Product Change Notice (PCN)

PCN Number: **PCN-0456192R-01**

Product(s) Affected: *PJ-042*

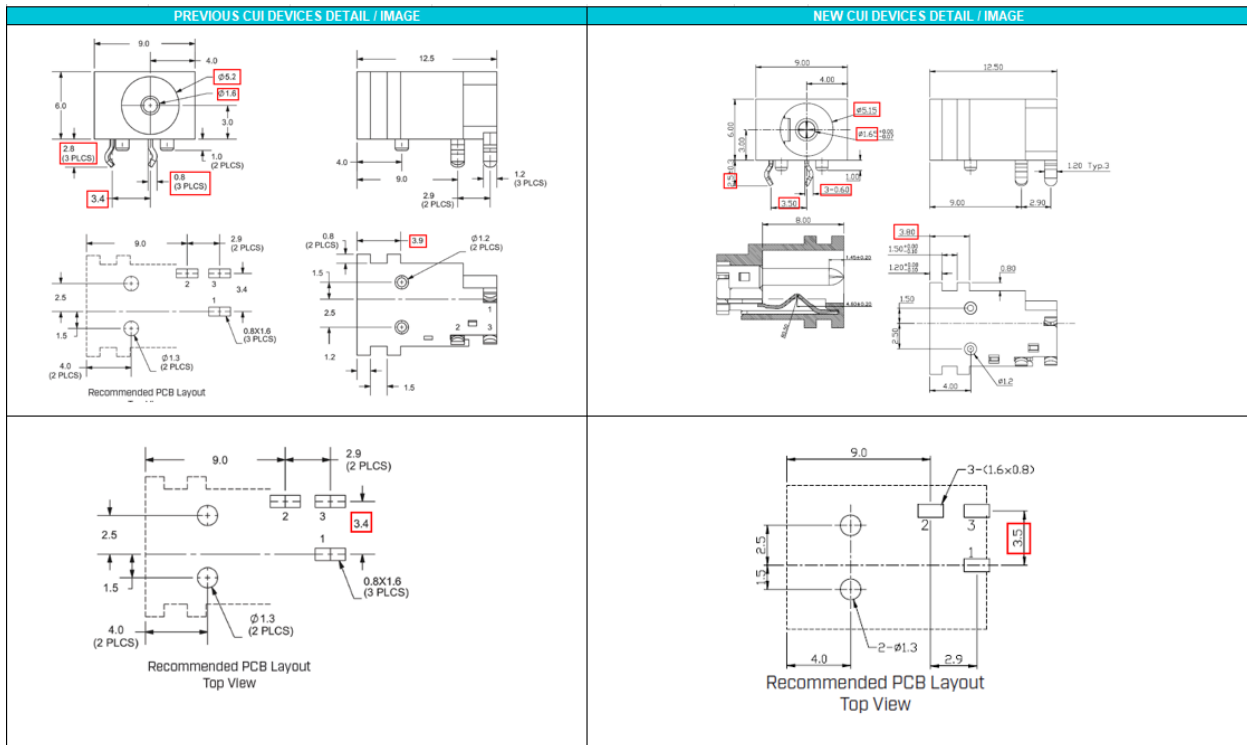
Description of Change: *New Factory Location. Product re-engineered for improved manufacturability and production yield. See image below for reference and check CUI Devices website for updated drawing. Cosmetic differences may be visible and not affect the form fit and function of the product.*

PREVIOUS CUI DEVICES DETAIL / IMAGE			NEW CUI DEVICES DETAIL / IMAGE		
DESCRIPTION	MATERIAL	PLATING/COLOR	DESCRIPTION	MATERIAL	PLATING/COLOR
center pin	brass	tin	center pin	bronze	tin
terminal 1	brass	tin	terminal 1	bronze t=0.35	tin
terminal 2	phosphor bronze t=0.3	tin	terminal 2	B2-Cu t=0.30	tin
terminal 3	brass t=0.3	tin	terminal 3	brass t=0.40	tin
housing	PAB6 (UL94V-0)	black	housing	PAB6-30%GF (UL94V-0)	black
MATING PLUG Jack Insertion Depth: 7.8 mm			MATING PLUG Jack Insertion Depth: 8.0 mm

Affected Date Code: All orders placed before **09/10/2024** will be pre-PCN parts. Orders placed after **09/10/2024** will be manufactured in accordance with the PCN. Please check updated 2D drawing on or after **09/10/2024**.
